Addendum No. 1

Project Name: N5012(1)1,2&4 Road Improvement Project in Sanostee, NM

Owner: Navajo Division of Transportation

4. Sheets 2, 3, 5, 8, 11, 17, 18, 19, 38, 39, 40, 61A, 61B, 65 and 66 of the N5012(1) plans have been revised. Revisions included changing the class of riprap from "Class 2" to "Class 1" and adding in the subgrade stabilization notes from the Pre-Proposal Meeting Agenda.

REGION	STATE	RESERVATION	ROUTE	PROJECT NO.	SHEET	TOTAL SHEETS
NORTH	NEW MEXICO	NAVAJO	N5012	N5012(1)1,2&4	38	75

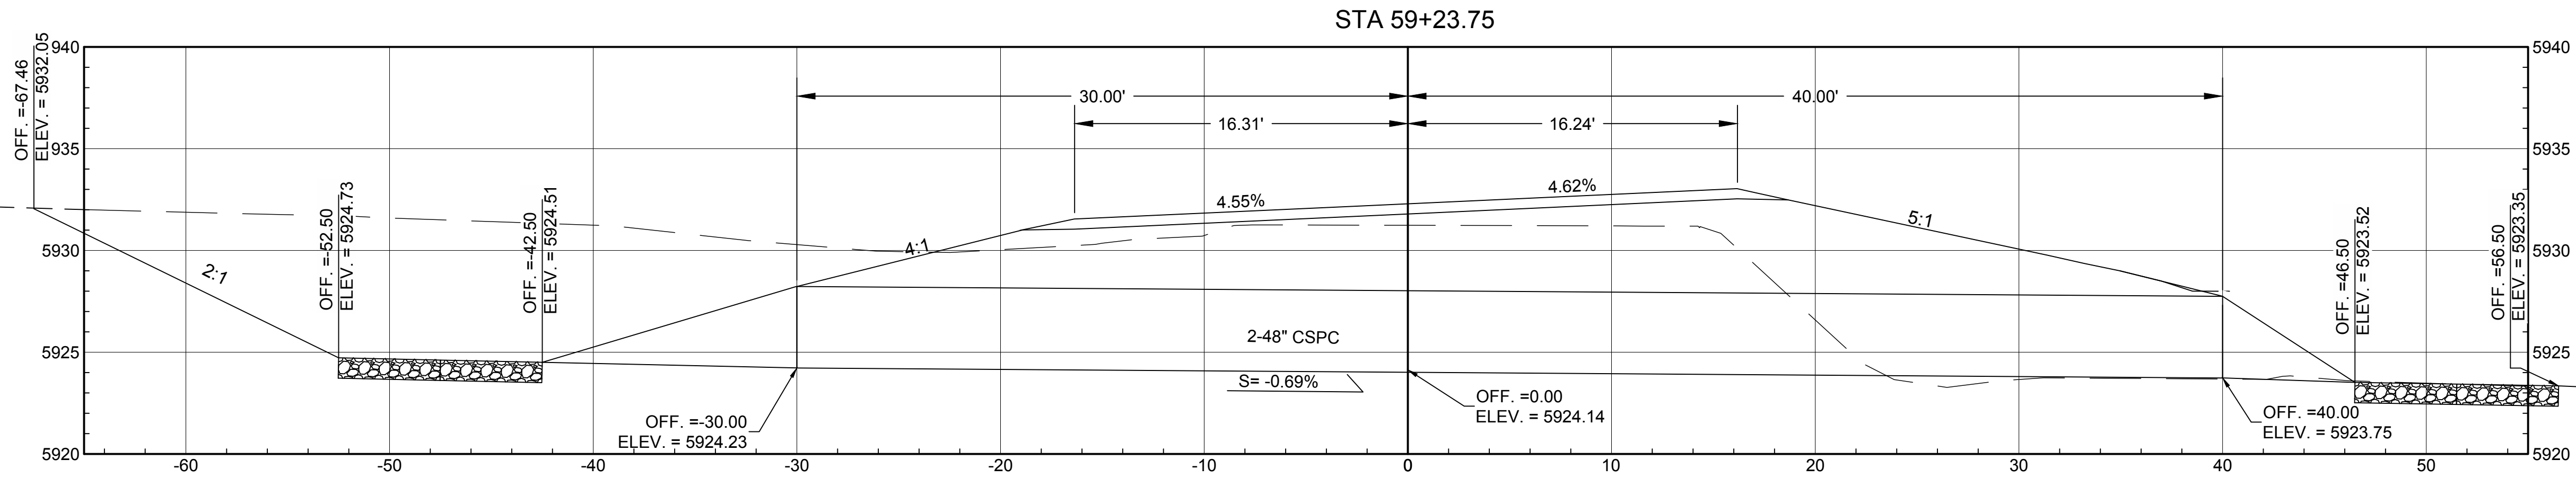
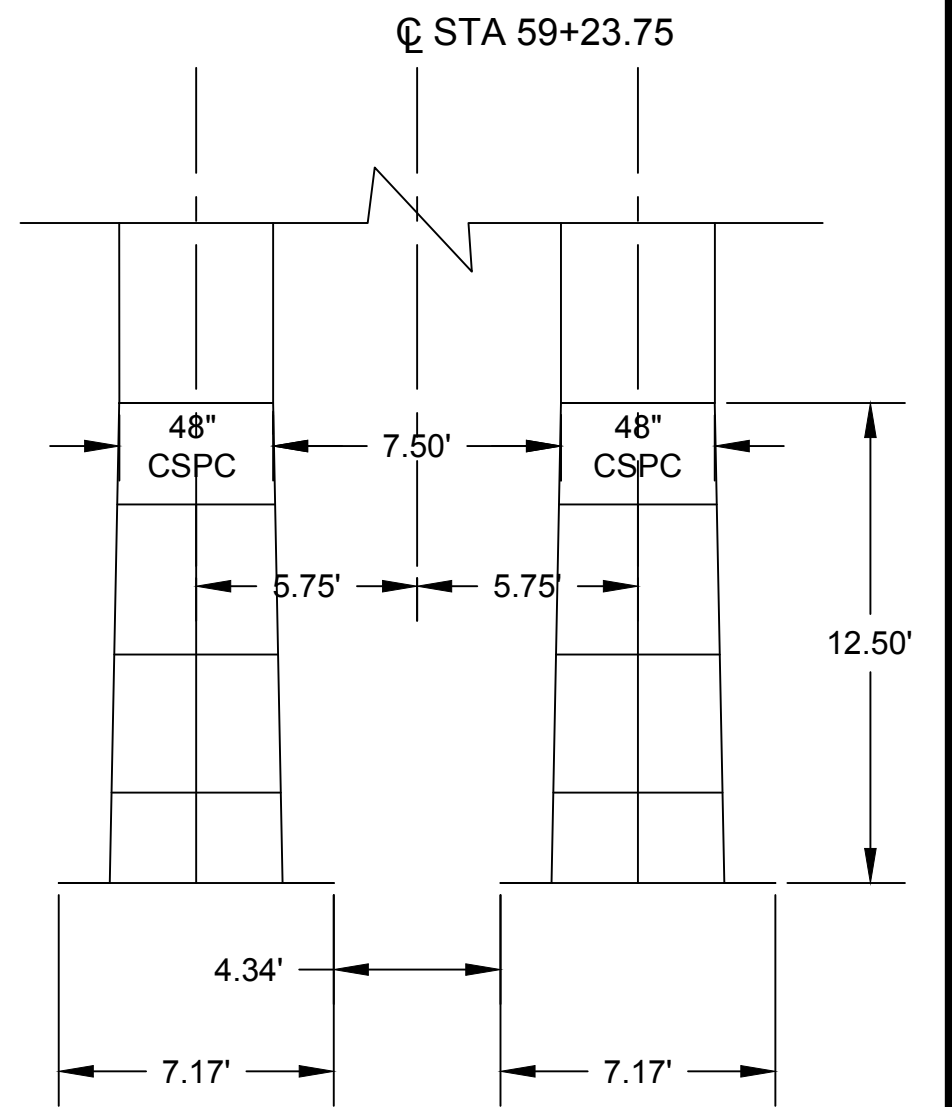
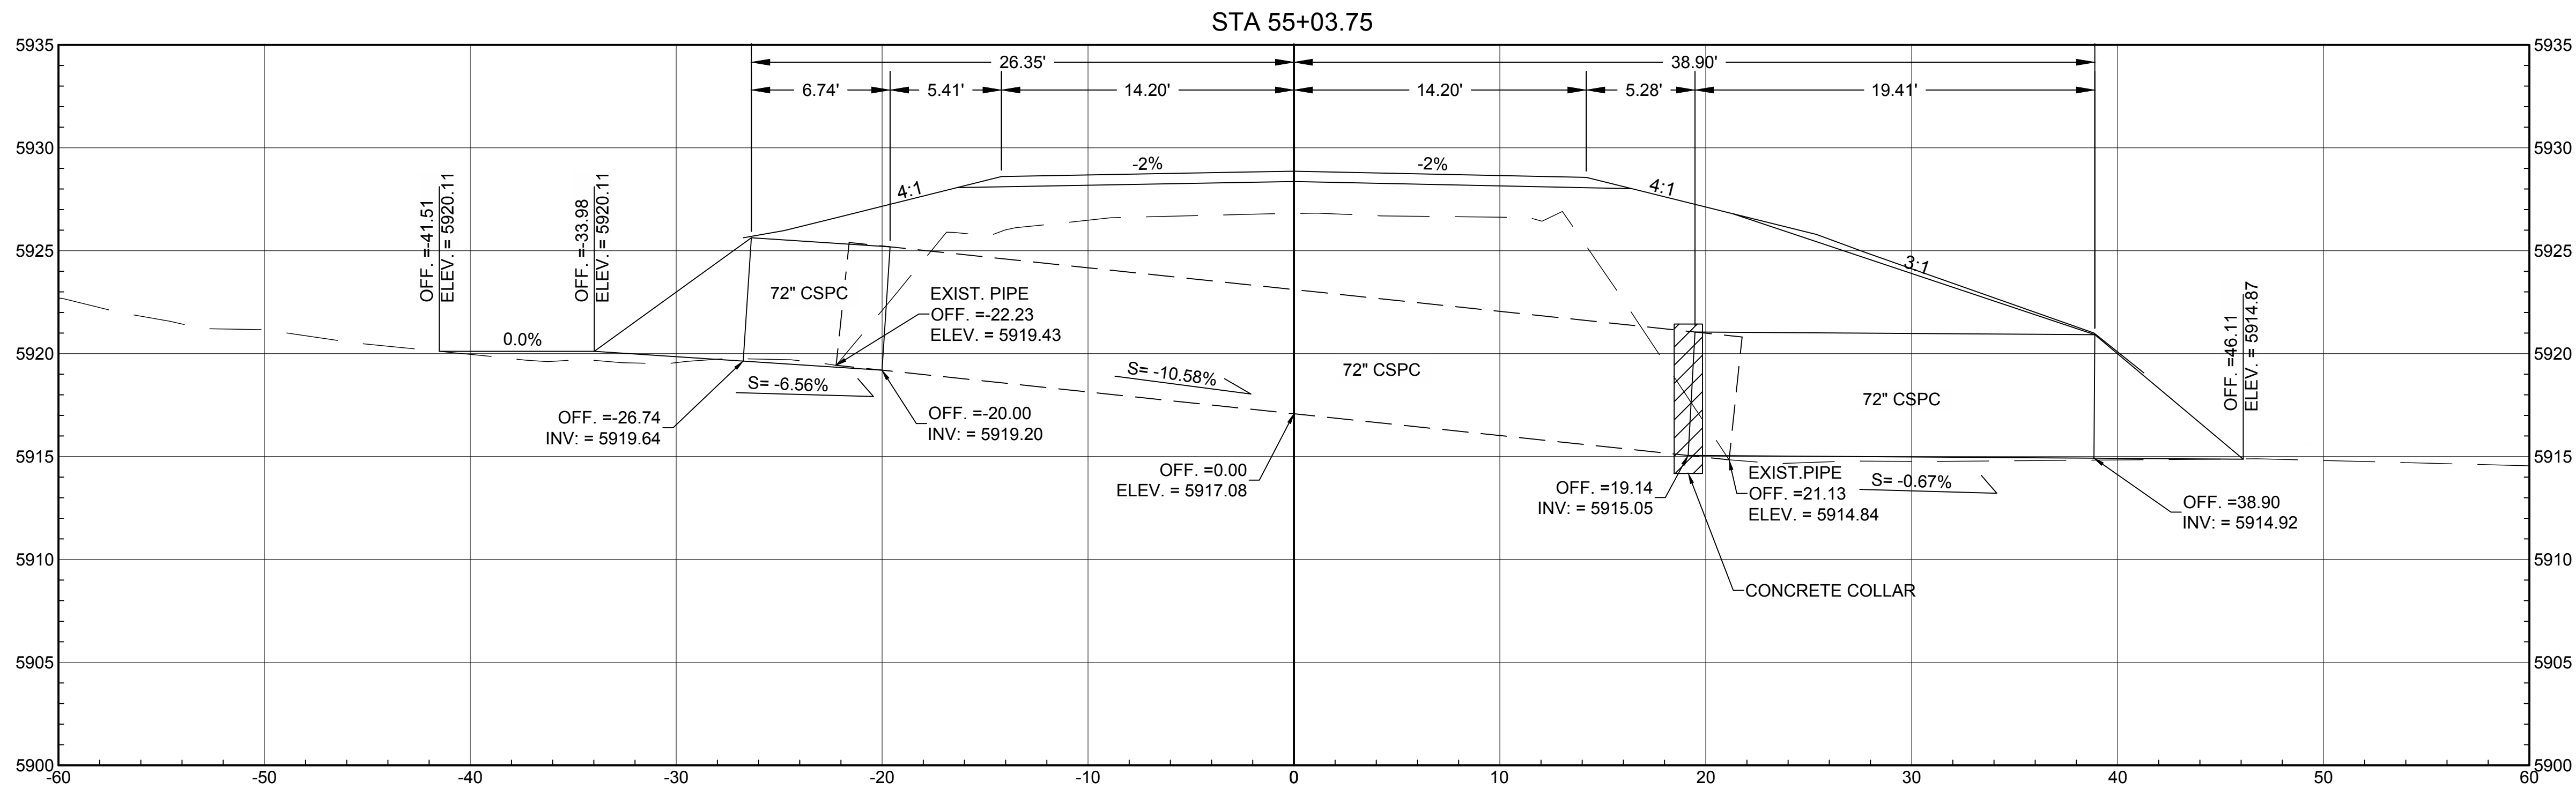
NOTE: REFERENCES WITHIN THIS
SHEET TO CLASS "A" RIPRAP IS
EQUIVALENT TO BID ITEM 25112-2000
WIRE-ENCLOSED RIPRAP, CLASS 1.

REVISED per ADDENDUM No. 1

REGION	STATE	RESERVATION	ROUTE	PROJECT NO.	SHEET	TOTAL SHEETS
NORTH	NEW MEXICO	NAVAJO	N5012	N5012(1)1,2&4	39	75

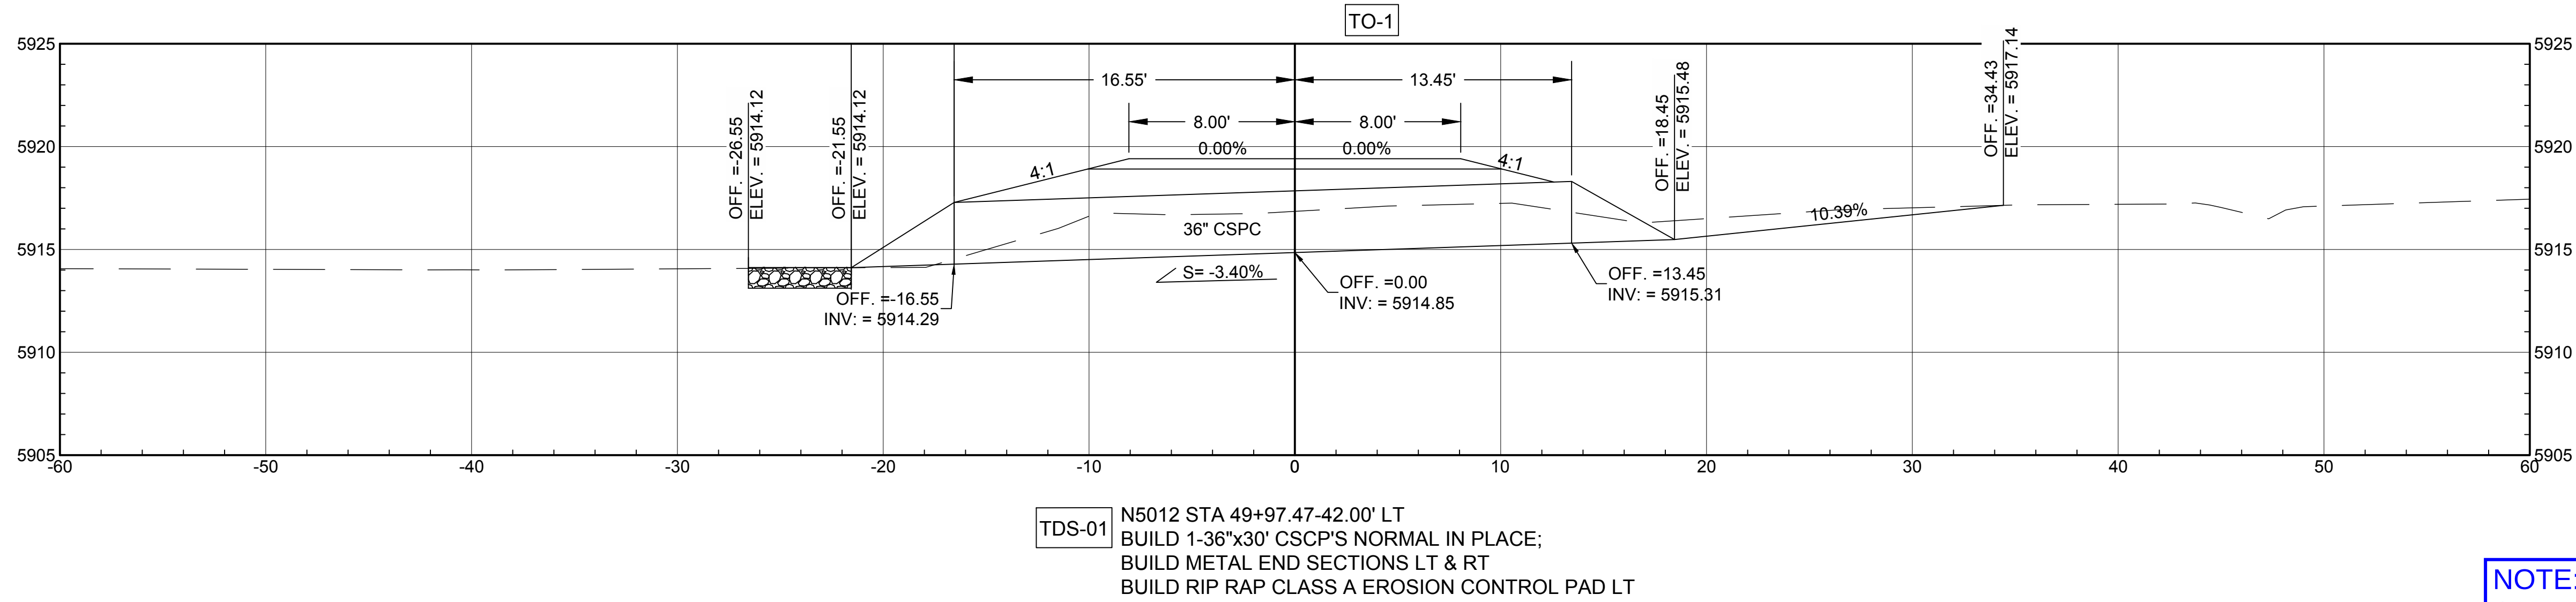
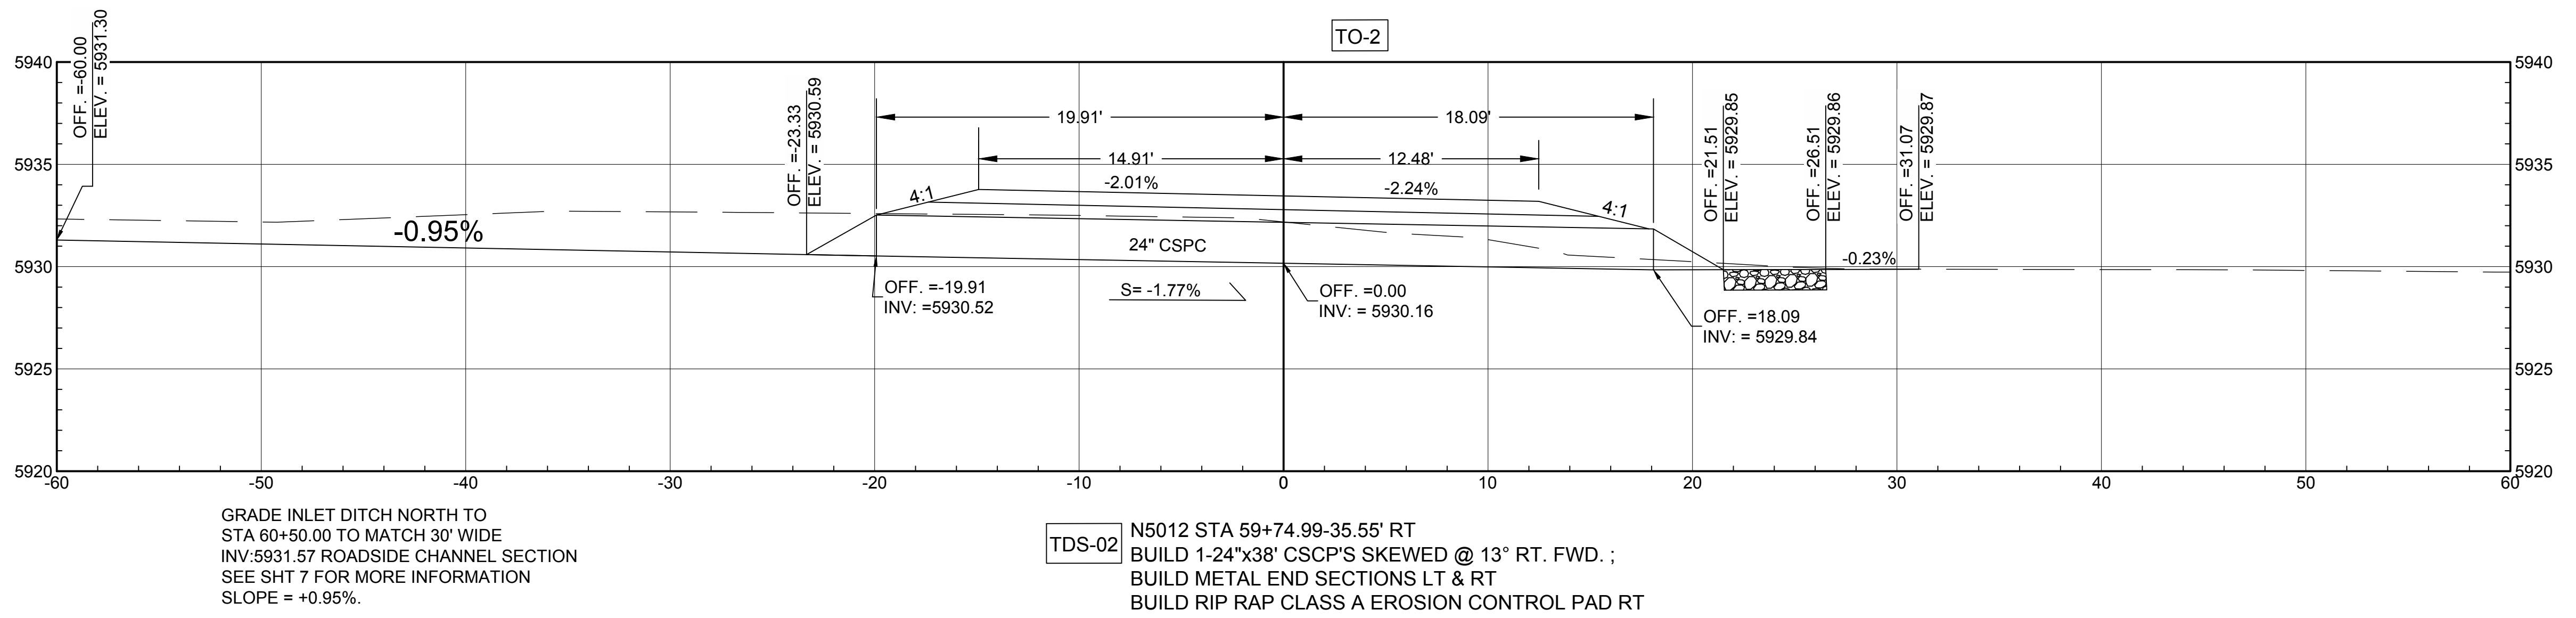
NOTE: REFERENCES WITHIN THIS SHEET TO CLASS "A" RIPRAP IS EQUIVALENT TO BID ITEM 25112-2000 WIRE-ENCLOSED RIPRAP, CLASS 1.

REVISED per ADDENDUM No. 1

REGION	STATE	RESERVATION	ROUTE	PROJECT NO.	SHEET	TOTAL SHEETS
NORTH	NEW MEXICO	NAVAJO	N5012	N5012(1)1,2&4	40	75

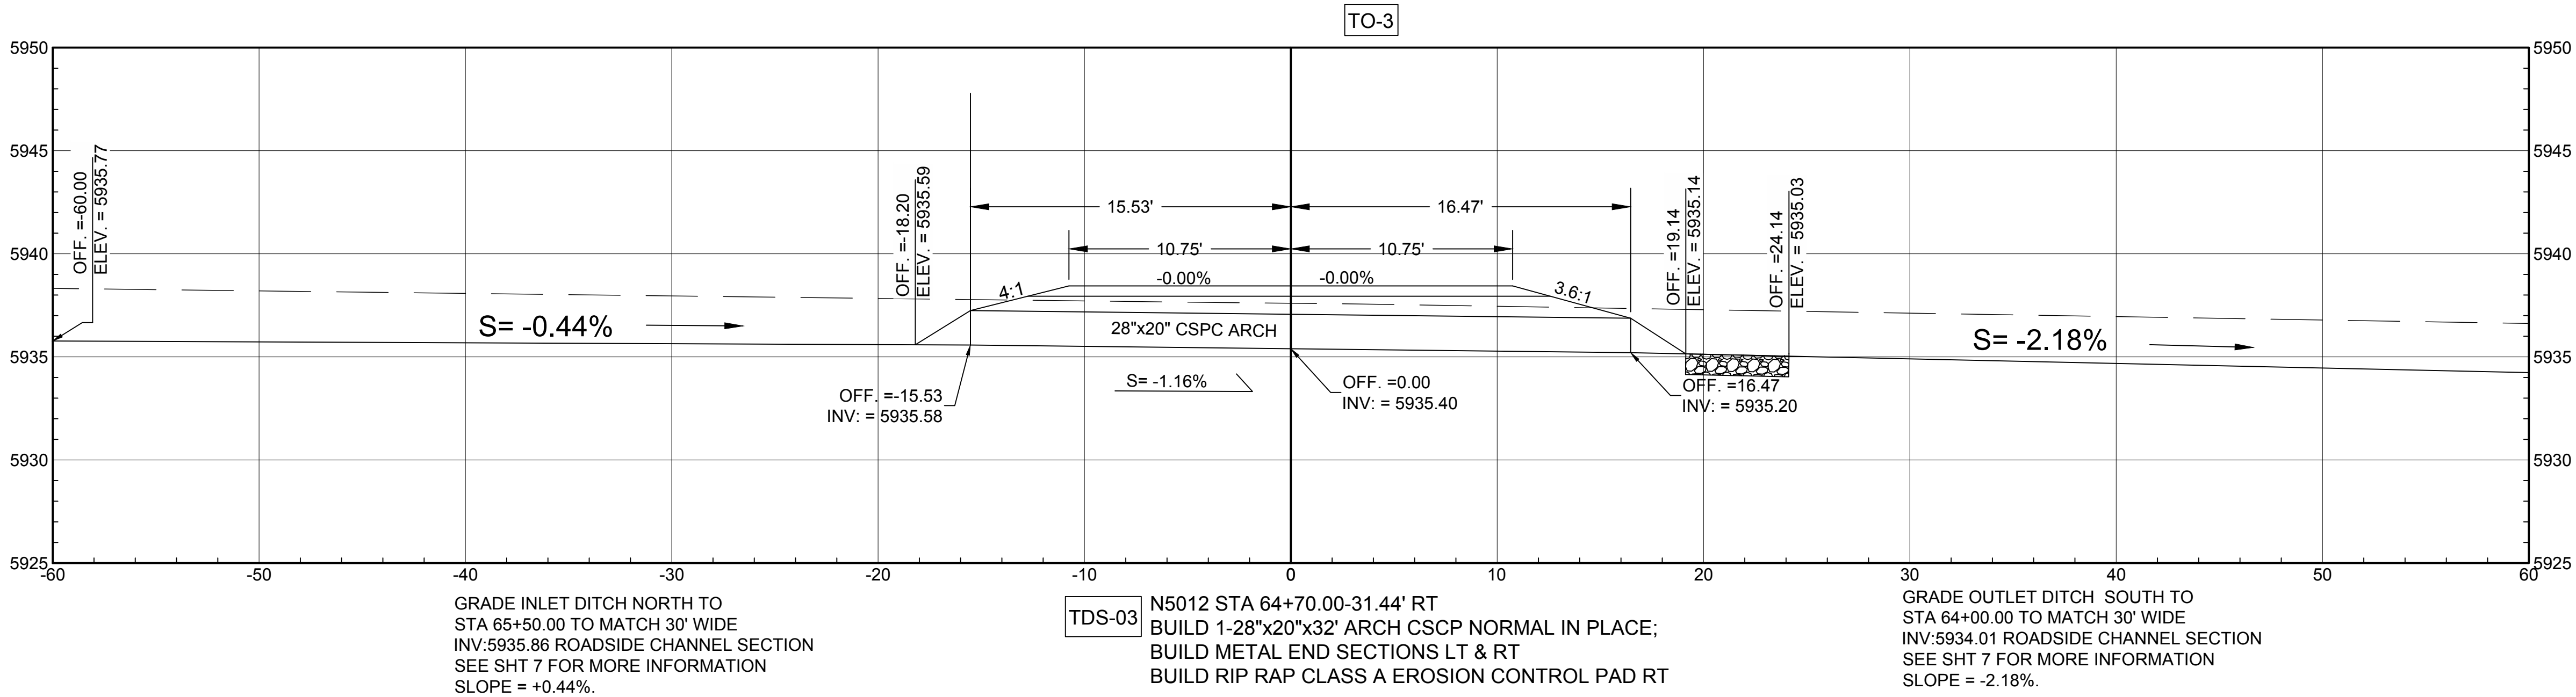
NOTE: REFERENCES WITHIN THIS SHEET TO CLASS "A" RIPRAP IS EQUIVALENT TO BID ITEM 25112-2000 WIRE-ENCLOSED RIPRAP, CLASS 1.

REVISED per ADDENDUM No. 1
